MEMORANDUM

To: Development Review Board
From: Mary O'Neil, AICP, Principal Planner
Date: July 7, 2020
RE: 225 Elmwood Avenue; ZP20-0858CA

Location: 225 Elmwood Avenue

Request: Demolish existing single family home, rebuild new single family home.

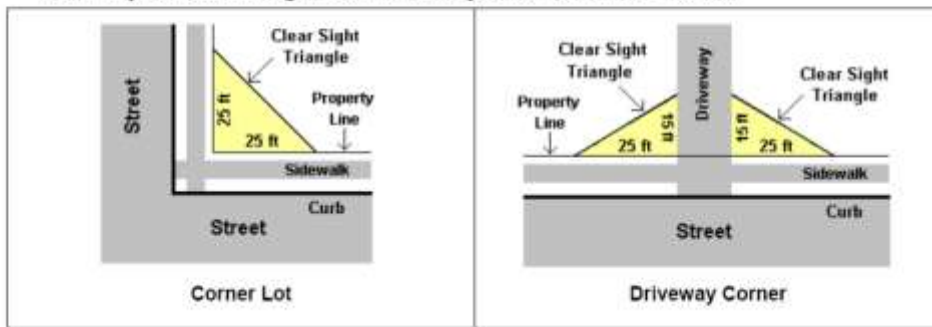
Two parking spaces are required for a single family home. While only one was originally requested, two may be permitted by the DRB under 4.4.5 (d) 1. A. As the driveway is

overgrown, it is not clear what the previous conditions were. The site plan of 6.30.2020 illustrates the desire for two spaces; discretionary by the DRB under Section 4.4.5 (d) 1. A. **Affirmative finding.**
